**ARCHITECTURAL REVIEW COMMITTEE MEETING**

1.	<b>414 San Mateo Avenue (AR-05-011)</b>  <b><u>Environmental Determination:</u></b> Categorical Exemption  <b><u>Zoning:</u></b> C-B-D (Central Business District)	Request for an Architectural Review Permit for revision to a previously approved facade per Chapter 12.108.010 of the San Bruno Zoning Ordinance. Michelle Chee (Owner/Applicant). <b>AR-05-011</b>
2.	<b>741 San Mateo Avenue (AR-06-001)</b>  <b><u>Environmental Determination:</u></b> Categorical Exemption  <b><u>Zoning:</u></b> C (Commercial District)	Request for an Architectural Review Permit for a new facade and signage per Chapter 12.108.010 of the San Bruno Zoning Ordinance. Guo Yu Lei (Owner); AMAssociates (Applicant). <b>AR-06-001</b>

3.	<p><b>495 San Mateo Avenue (AR-06-005)</b></p> <p><b><u>Environmental Determination:</u></b> Categorical Exemption</p> <p><b><u>Zoning:</u></b> C-B-D (Central Business District)</p>	<p>Request for an Architectural Review Permit for a new façade and signage per Chapter 12.108.010 of the San Bruno Zoning Ordinance. A&amp;M Pizza Mill LLC DBA Straw Hat (Owner); Baukunst (Applicant). <b>AR-06-005</b></p>

4.	<p><b>1150 El Camino Real (AR-06-

PROPOSED --  
ELEVATIONS

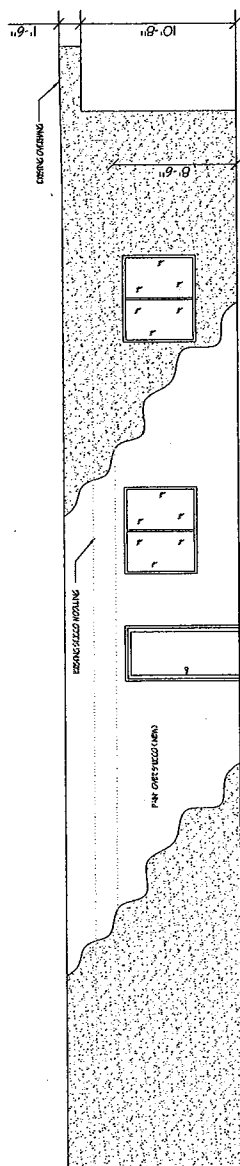
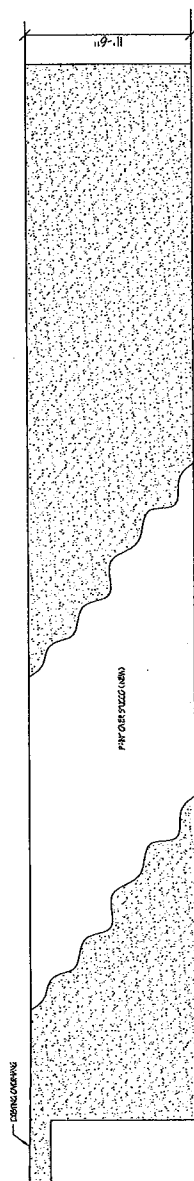
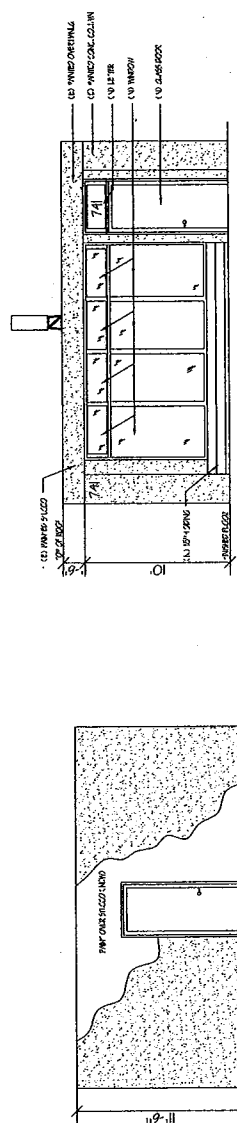
12. Applicant shall submit new signage plan for review. Roof sign is a legal non-conforming sign and any changes to the sign will require that it meets all San Bruno Zoning Ordinance requirements. Roof sign must be at least 8'-0" from front of building and 4'-0" from any side wall. The sign colors should be revised to have a dark background with a light colored lettering.

13. Applicant shall revise the front elevation to relocate or screen the existing utility boxes that are currently exposed on the front of the building.

FOR SIGNAGE PURPOSES ONLY  
SIGNAGE PACKAGE PREPARED BY SHCC  
ACTUAL ELEVATION TO BE VERIFIED  
SEE SHEET A3.2

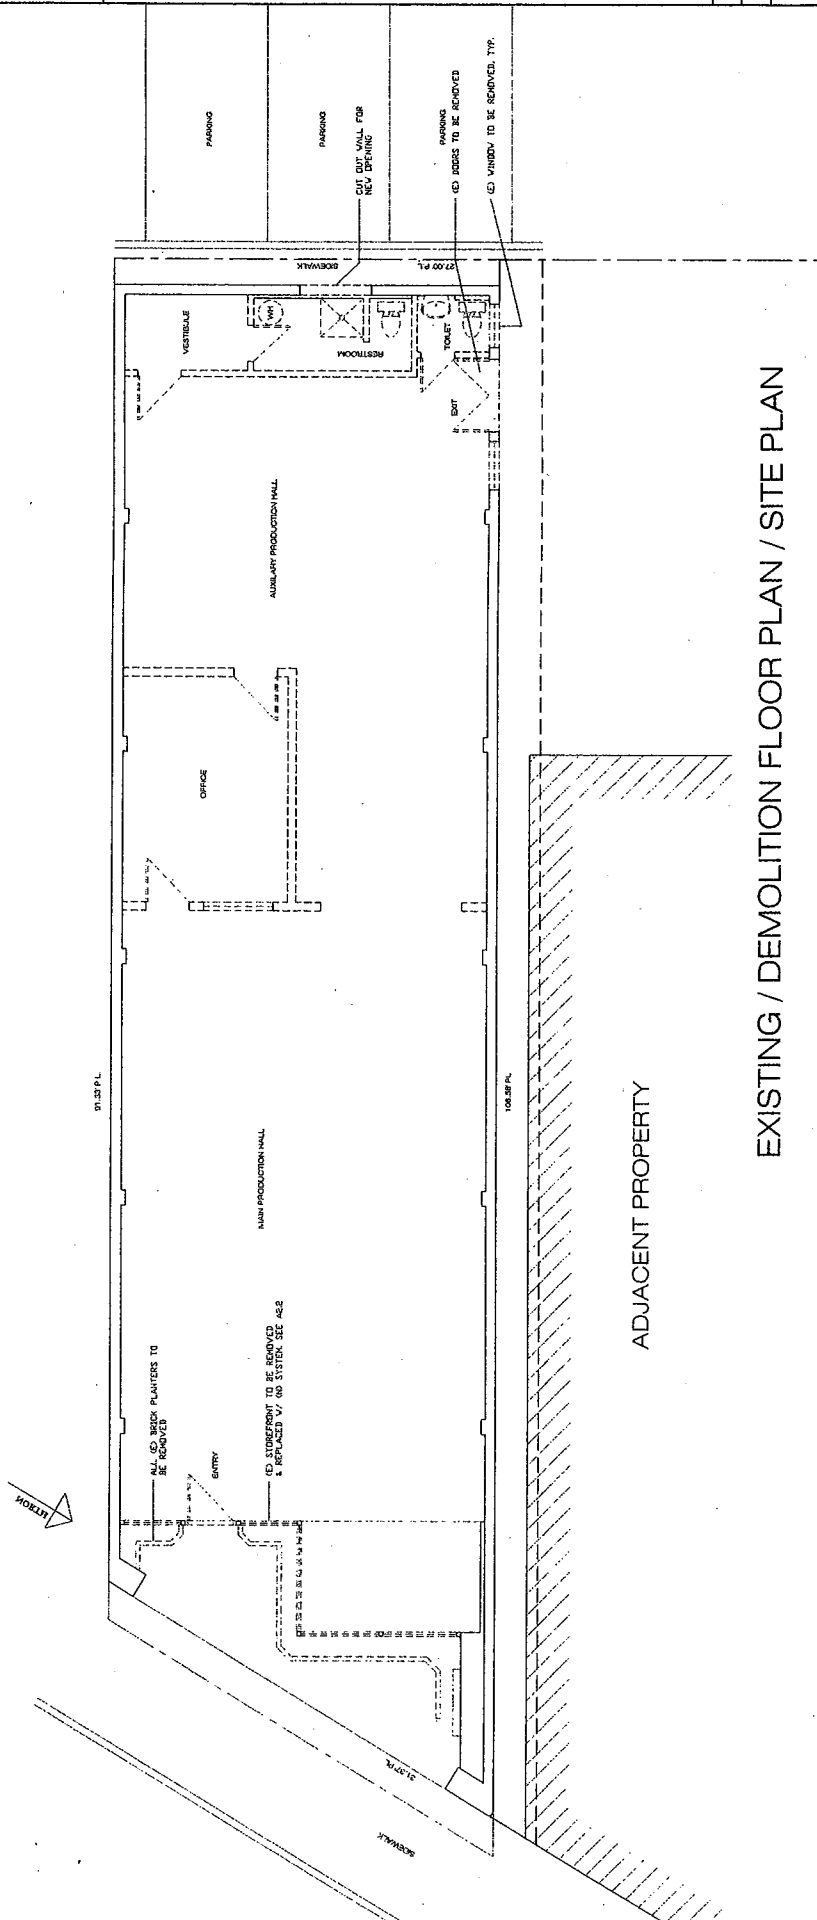
The applicant should revise the front elevation to provide a more inviting entrance to what should be a popular destination for the local and regional area. With the proposal for street tables, which normally is
